**From:** [Wells, Shelly, EMNRD](#)  
**To:** [Hayden Acosta](#)  
**Cc:** [gdcofer\\_cofelandco.com](#); [Lynn Acosta](#); [Austin Weyant](#); [Bratcher, Michael, EMNRD](#)  
**Subject:** RE: [EXTERNAL] Confirmation Sampling Plan for the State Land 76 #001 - nOY1716629707  
**Date:** Friday, May 16, 2025 8:42:00 AM  
**Attachments:** [image001.png](#)

On behalf of Cofer & Co, Strata Resources is submitting this Confirmation Sampling Plan for the release at State Land 76 #001 Well and Tank Battery (Incident nOY1716629707). Based on the history of this incident, Strata felt it would be best to submit a sampling plan for review prior to conducting confirmation sampling. Our aim is to ensure that the proposed approach aligns with your expectations and requirements.

SUBJECT: Confirmation Sampling Plan for the State Land 76 #001 Well Tank Battery (State Land 76) Release (nOY1716629707), Lea County, New Mexico

FIGURE 1  
State Land 76  
Drone imagery  
Surveyed Areas

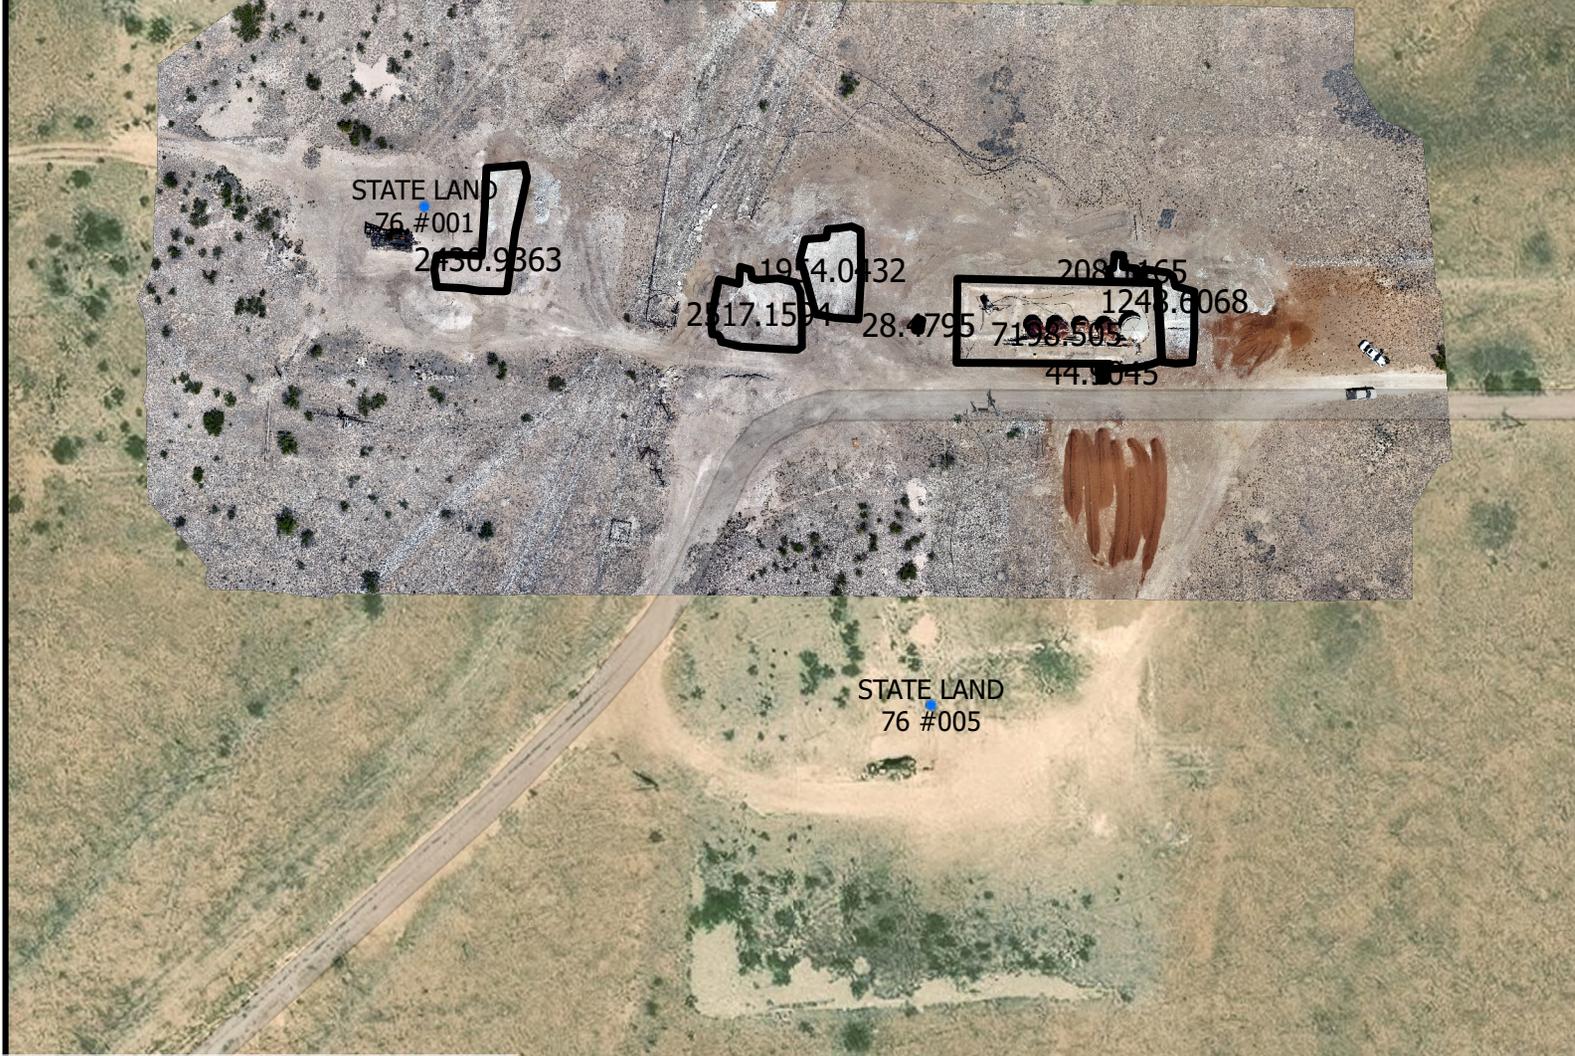
The proposed Confirmation Sampling Plan is not approved. Due to the conflicting depths and shapes of the excavations in the Wellpad location, the Former Heater Treater location and Firewall locations these areas are required to be re-excavated to prior depths. Confirmation samples are required to be collected every 200 ft<sup>2</sup> from the base and every 200 ft<sup>2</sup> from the sidewalls of the excavations. The excavated soil will need to be sampled with one five-point composite sample collected for every 15 cubic yards if wanting to re-use as backfill. In addition, the tank battery requires further delineation. To obtain delineation in the tank battery area, samples will need to be discrete and collected at surface, 1', 2', 3', and 4' depths and submitted to a laboratory to be analyzed for all Table I constituents. TH-5, TH-6 and TH-7 collected outside the tank battery exceeded reclamation standards. Horizontal delineation should be achieved for these sample points and must be to reclamation standards. Should delineation results come back above the Closure Criteria, remediation will need to occur pursuant to 19.15.29.12 NMAC or a deferral requested after removing contaminants to the maximum extent practicable. Remediation on an active site can be deferred in areas immediately under or around production equipment such as production tanks, wellheads, and pipelines where remediation could cause a major facility deconstruction so long as the contamination is fully delineated and does not cause an imminent risk to human health, the environment, or ground water. The deferral request must specify which sample points are being requested for deferral including an explanation why the contaminants can't be removed. Photographic evidence must be obtained throughout the remediation process of each of the open excavations and included with the report pursuant to 19.15.29.12(E)1(b) NMAC.
